HISTORIC AND DESIGN REVIEW COMMISSION

HDRC CASE NO: 2025-093
COMMON NAME: 508 & 510 BOOKER ALLEY
LEGAL DESCRIPTION: NCB 560 BLK 18 LOT W 21.2 FT OF E 30 FT OF N 86.62 FT OF 9
NCB 560 BLK 18 LOT E 8.8 OF N 86.62 OF 9 & W 29.7 OF N 86.62 FT
OF 9
ZONING: R-4, H
CITY COUNCIL DIST.: 2
DISTRICT: Dignowity Hill Historic District
APPLICANT: Felix Ziga/Ziga Architecture Studio, PLLC
OWNER: RAMIRO MORENO/RAMIRO MORENO
TYPE OF WORK: Construction of a 2.5-story, single family residential structure and a
detached, 2-story accessory structure
APPLICATION RECEIVED: April 10, 2025
60-DAY REVIEW: June 9, 2025
CASE MANAGER: Edward Hall
REQUEST:

1. Construct a 2.5-story, single-family residential structure on the lot identified as 510 Booker Alley.
2. Construct a 2-story, residential structure on the lot identified as 508 Booker Alley. The structure has been positioned as an accessory structure to the structure proposed at 510 Booker Alley.

1 FRONT ELEVATION

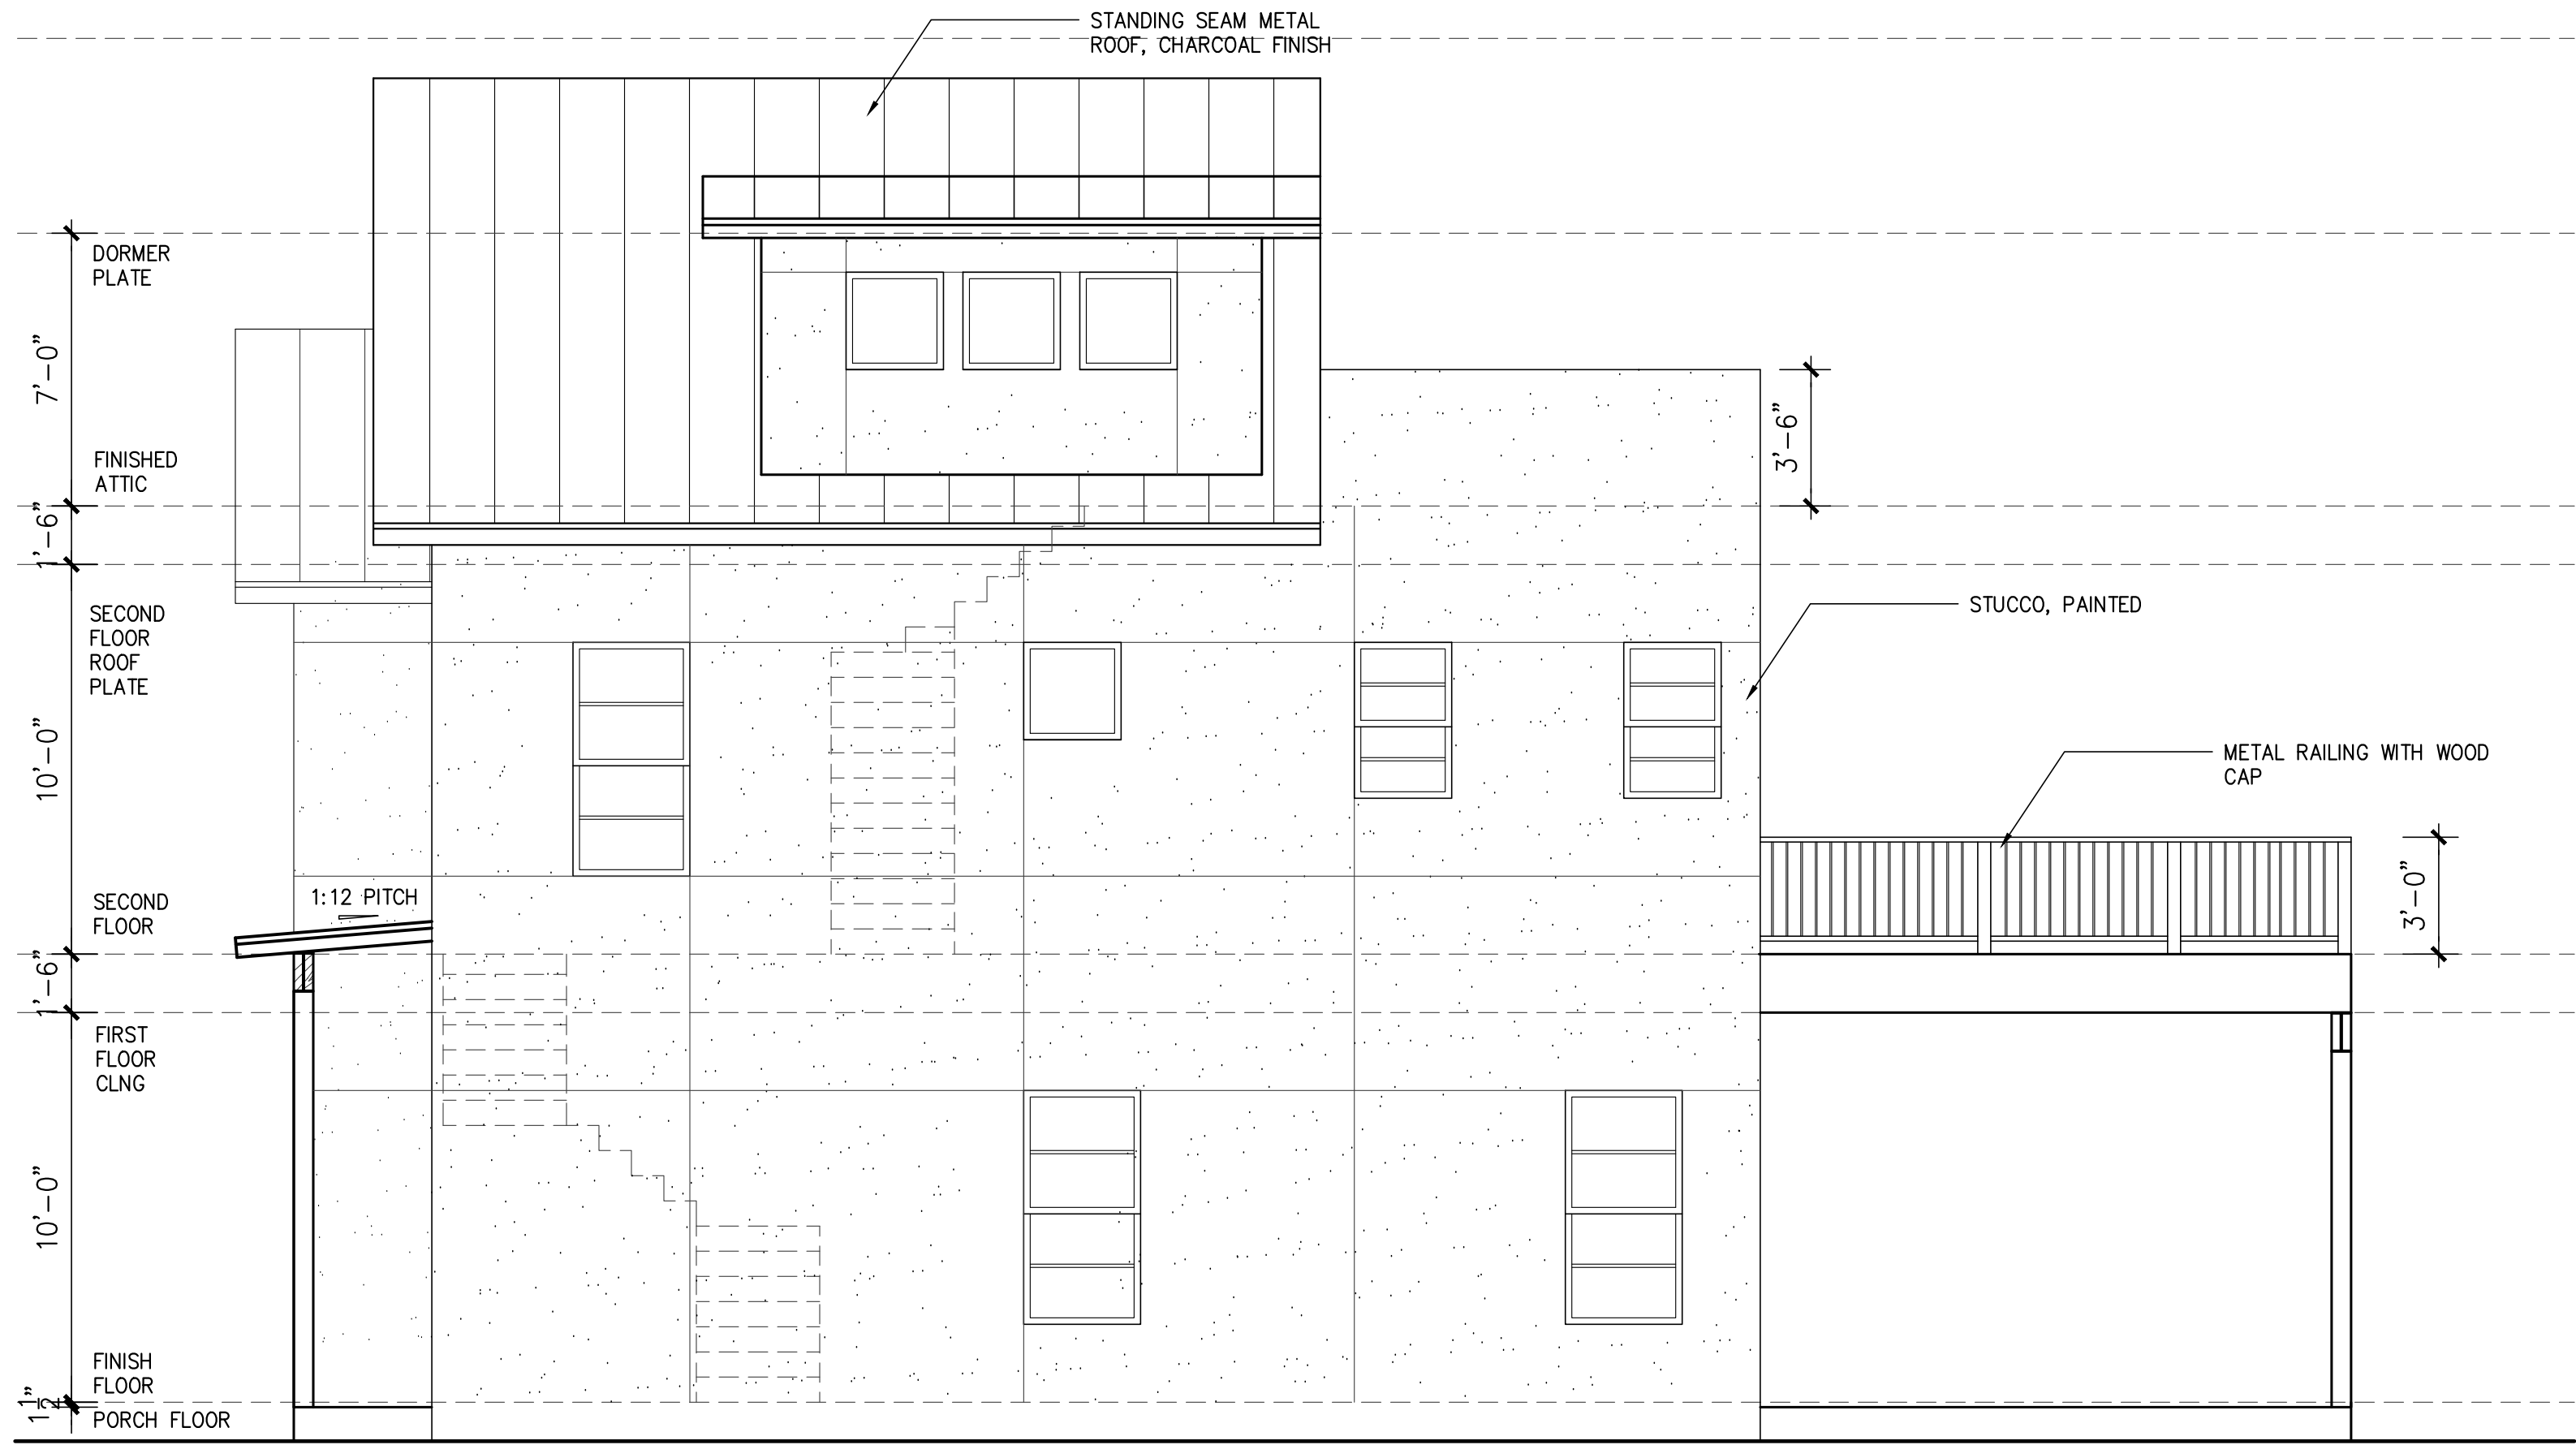
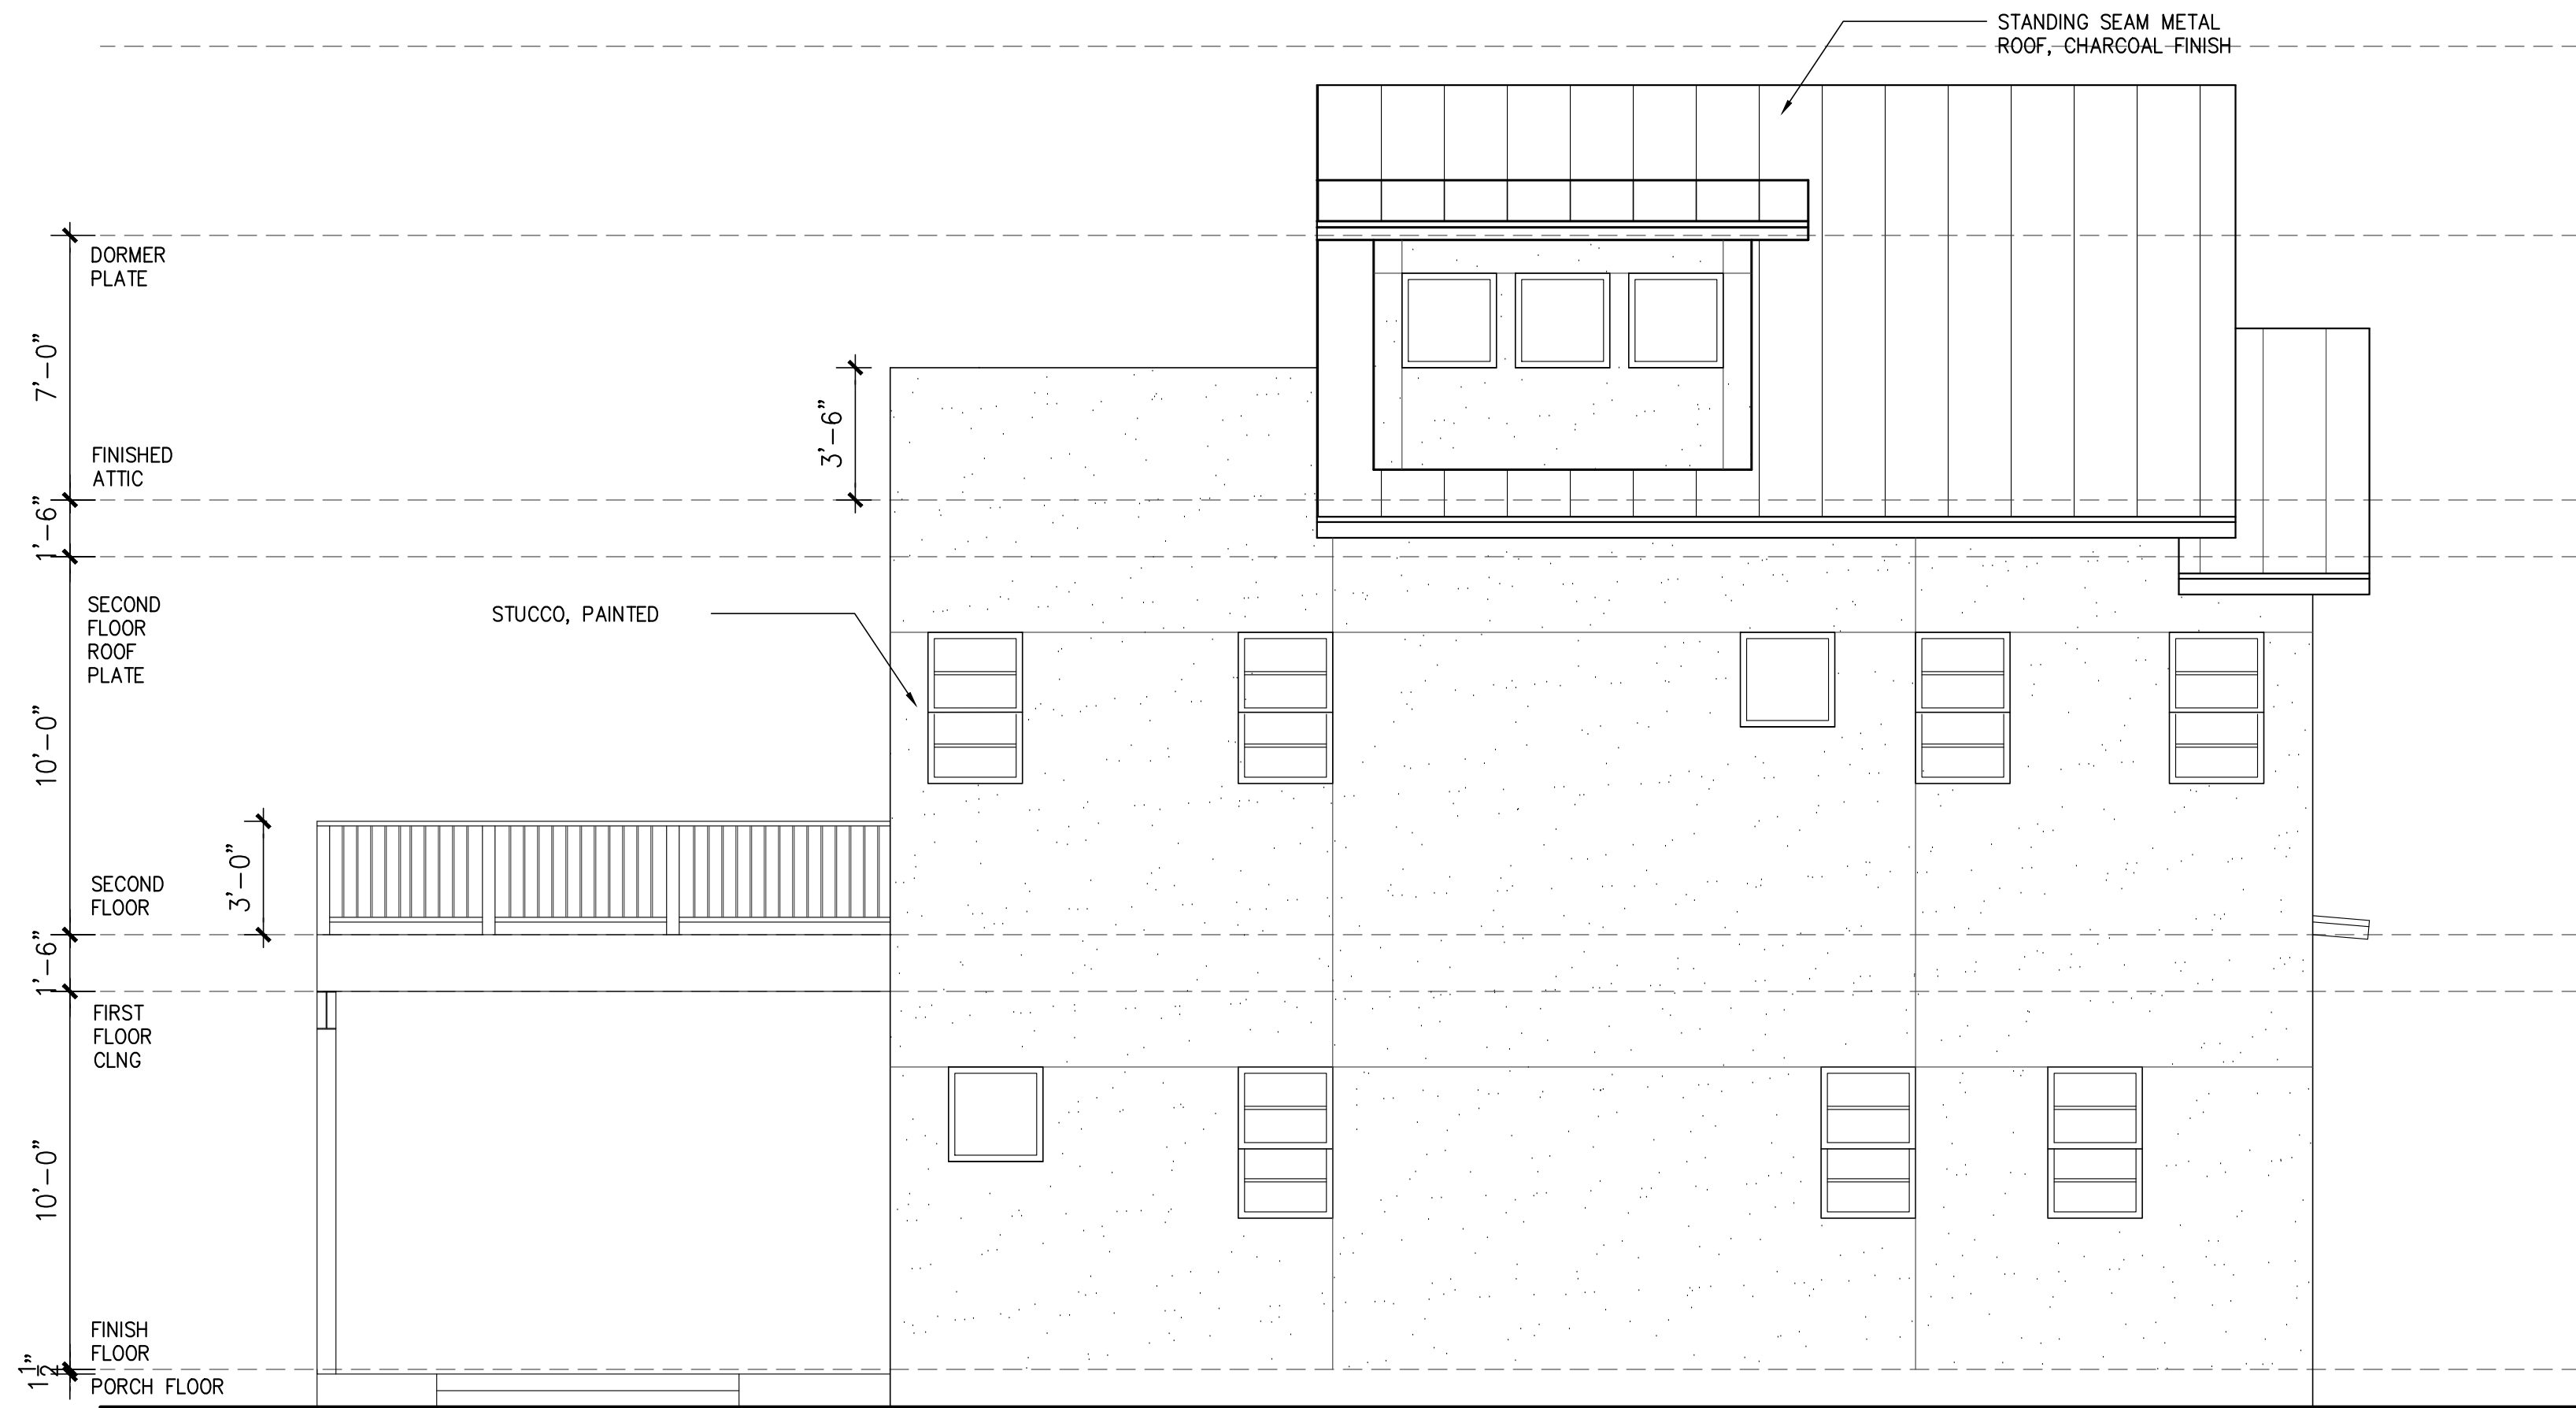
- viii. That the proposed structure's massing be modified to feature traditionally positioned and massed porch elements. ***Below are two photos; the first is of a historic houses' porches and the second is of new construction which comparably incorporates the porch massing into the new construction. The porch should be incorporated into the whole massing and design, not simply a stoop with a canopy or awning.***

front porch that is integrated into the massing of the house, and the alternating masses and forms that generally makes the proposed design fall outside of what architecturally would be consistent with historic structures found within the historic district. ***I believe this has been addressed in the various comments above, but if not, please let me know and I can clarify.***

The proposed front elevation has been revised to incorporate a front porch.

All elevations have been revised throughout to incorporate a more appropriate massing and form, incorporate a front porch and to make it overall consistent with the guidelines.
